Jerry Schoeppner, Director
Mining and Minerals Division
NM Energy, Minerals and Natural Resources Department
1220 So. Saint Francis Drive
Santa Fe, New Mexico 87505

November 18, 2022

Re: **Comments on Revised October 2021 CCP update for MMD Permit No. SF002RE,
LAC Minerals (USA) LLC Cunningham Hill Mine**

Figures 1 and 2. Graphs of POINT PRECIPITATION FREQUENCY ESTIMATES, NOAA Atlas 14, Volume 1, Version 5 GOLDEN Station ID: 29-3592 Location name: Sandia Park, New Mexico, USA*

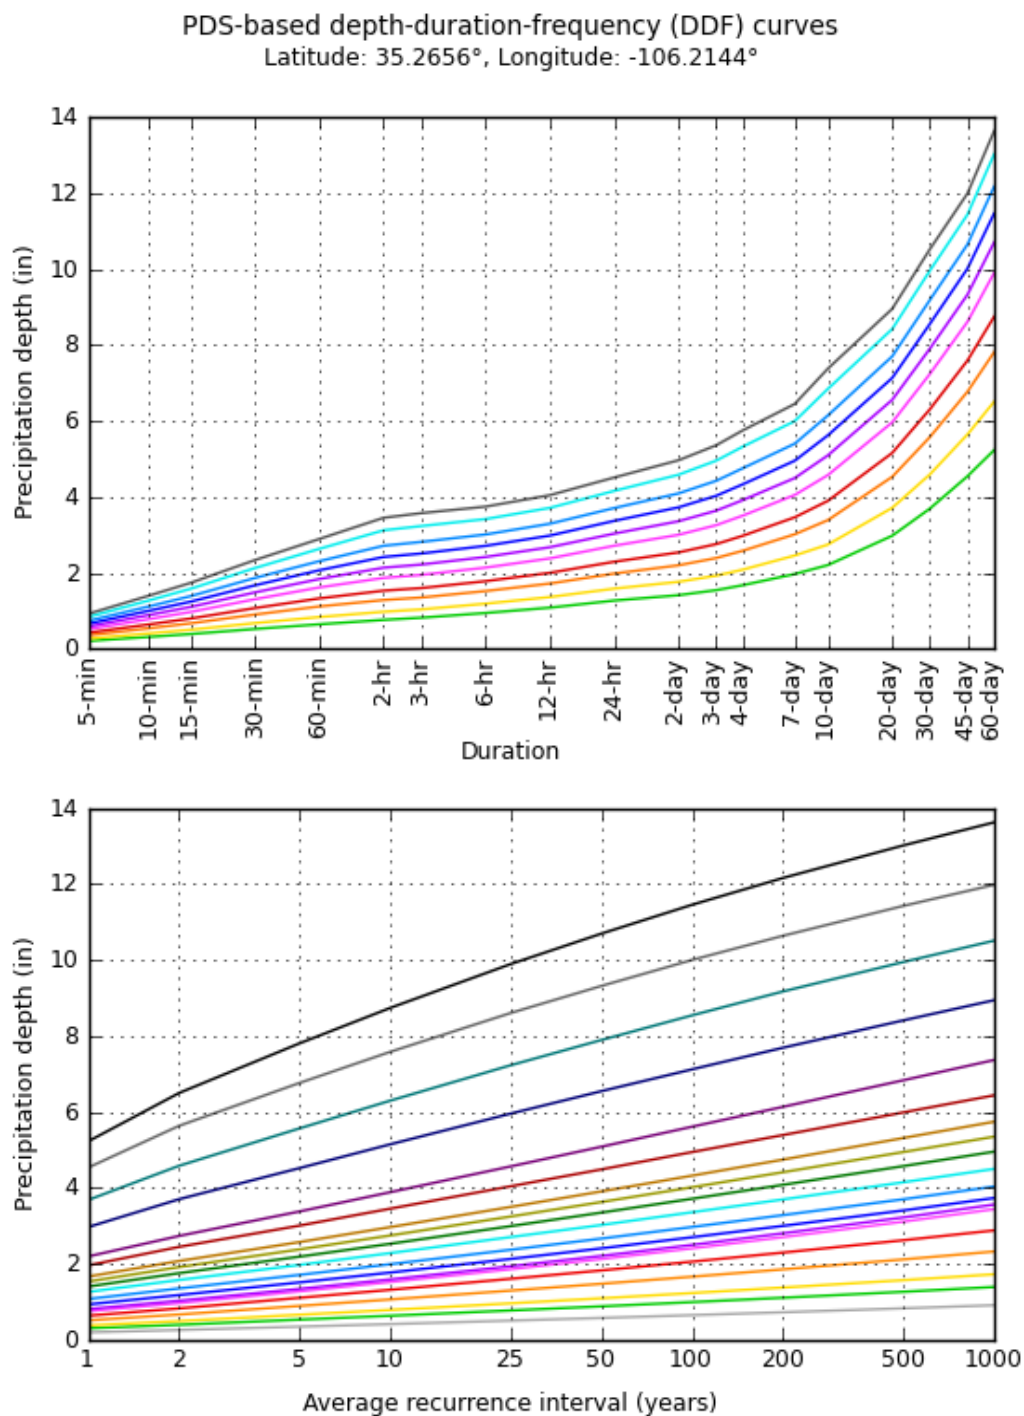
The National Weather Service provides information for specific weather stations including the Golden station referenced in the CHM CCP.⁵ As shown in Table 1 and Figures 1 and 2, the expected precipitation from a 1 in 100 year 24-hr storm event is estimated at 3.37 inches whereas a 1 in 1,000 year 24-hr event is estimated at 4.51 inches. Precipitation from a 1 in 100-year wet period of 30-days is estimated at 8.55 inches whereas a 1 in 1,000 year 30-day event is estimated at 10.5 inches. As has been experienced over the past decade⁶, 1 in 100 year 24-hr storm events are without question becoming more frequent, and 1 in 1,000-year events have occurred in the recent past and are equally if not more likely to occur in the future. This past 2022 Monsoon's precipitation amount was the second wettest in the 25-year period of record kept by Santa Fe County as shown in Figure 3.

Recommendations: The CHM CHP should be revised to recognize and address how climate is expected to be affected by climate change. The agencies should take into consideration the potential for more frequent intense storm events and wet years in their consideration as to the design, construction, maintenance and replacement of engineered covers and stormwater controls features as discussed later in these comments. Additionally, any models or other information that has been produced on behalf of LAC should be based on actual daily data and not average data which significantly compromises such efforts.

Table 4.

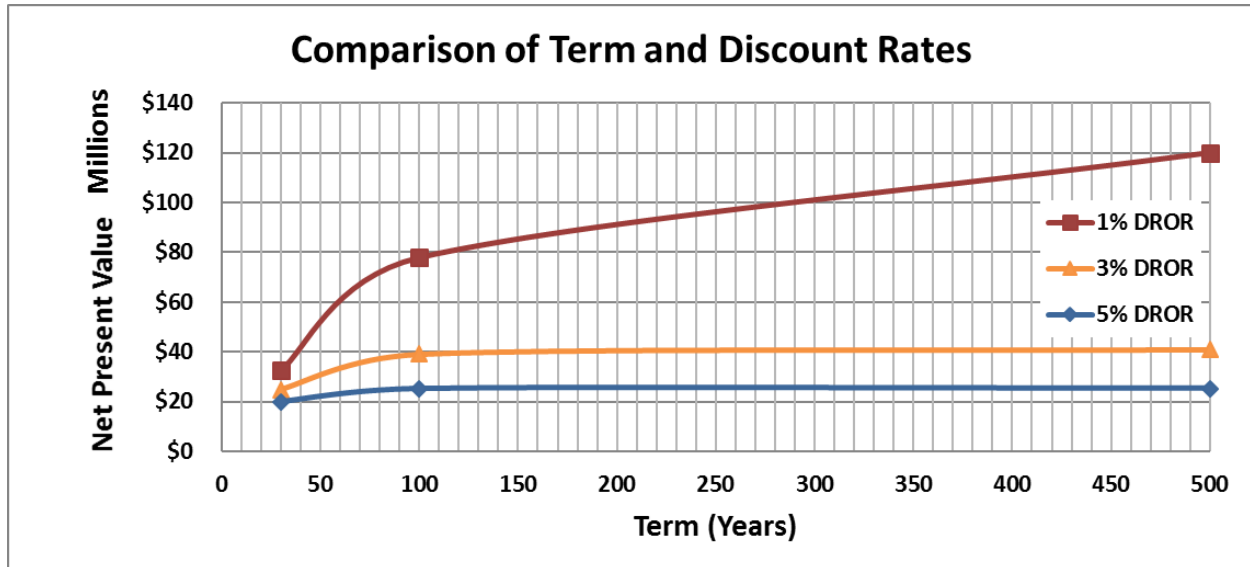
In particular the requirement from NMED to consider long-term costs for activities for 100 years is significant in that the use of that time period is intended to address long-term costs that could actually occur over hundreds, thousands and even tens of thousands of years into the future if present circumstances were to be applied. The recognition that the CHM is not a walk-away proposition is important in that it signifies that in order to ensure that the liability for conducting the necessary future monitoring, maintenance and water treatment tasks does not ultimately become a public/taxpayer liability, a cash or equivalent trust fund based on conservative fiscal assumptions relative to financial assurance must be established. This means that in addition to ensuring the cost estimate is accurate, the estimate should also be performed assuming a longer time period such as 500-years, and a using a conservative assumption as to future inflation and interest, and assume a low net discount rate, such as 1%. How this approach affects the amount of financial assurance is shown in Table 4.

Depending on the Discounted Rate of Return (DROR), which is the rate of interest received on funds invested minus the inflation rate, the impact on the amount of funds estimated is significant. For a 100-year period, using this example, a 5% DROR would result in a Net Present Value (NPV) being calculated of approximately \$25M, whereas using a 3% DROR would result in a NPV of approximately \$38M, and a 1% DROR would result in a NPV of approximately \$75M. It should be noted that currently, with inflation exceeding the interest rate obtainable on typical investment funds appropriate for financial assurance, the DROR would be negative resulting in an even larger amount of financial assurance being necessary than that calculated for the 1% case.

The impact of using a 500-year period is also demonstrated in Table 4. If a 5% DROR is used the result would be to add less than a percent to the NPV. If 3% is used the result would be to increase the amount from approximately \$38M to \$41M. However, if a conservative rate of 1% is used the NPV increases from approximately \$75M if 100 years is used to approximately \$120M if 500 years is used.
